August 31, 2021

SUBJECT: Response to Site Investigation Work Plan
ChemDesign Products, Inc. (PFAS)
2 Stanton Street, Marinette, WI
BRRTS #02-38-583852

Figure-1. ChemDesign Leased Property and General Activities by Location

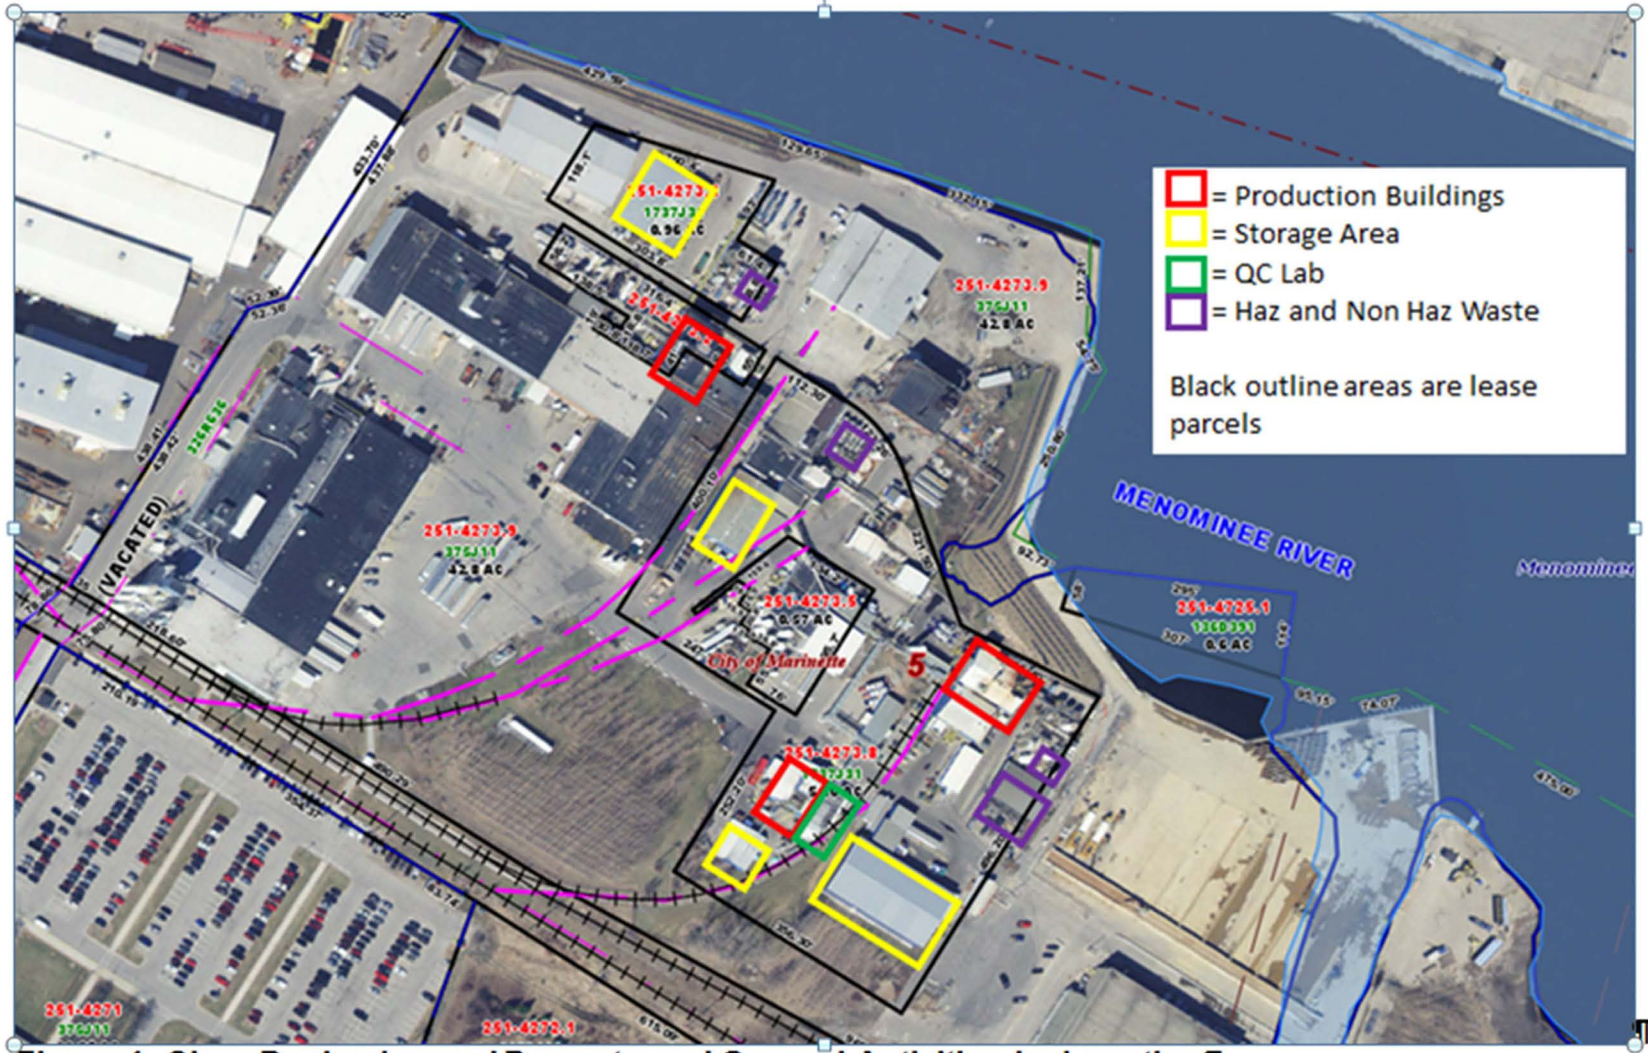
- Collection of soil samples from 11 locations on the Site in the vicinity of ChemDesign's operations that handle PFAS-containing material, including one sample near Building 69 where AFFF was historically deployed for testing of the fire suppression system (Exhibit 3 in **Attachment A**). Up to two samples will be collected from each location; one from unsaturated soil in the upper 4 feet, and a second from between 4 and 10 feet below ground surface (ft bgs), if unsaturated soil is present in this deeper zone².

- Include discussion of the activities where ChemDesign has air permits at the Site, if there are PFAS containing materials used within these activities, and the potential for PFAS air emissions from these activities. Speak to any processes where PFAS could be mobilized in air via aerosols or steam (Wis. Adm. Code NR § 716.11(5)(a)). (Remove the proposed air sample location from the figures if no air sampling is performed).
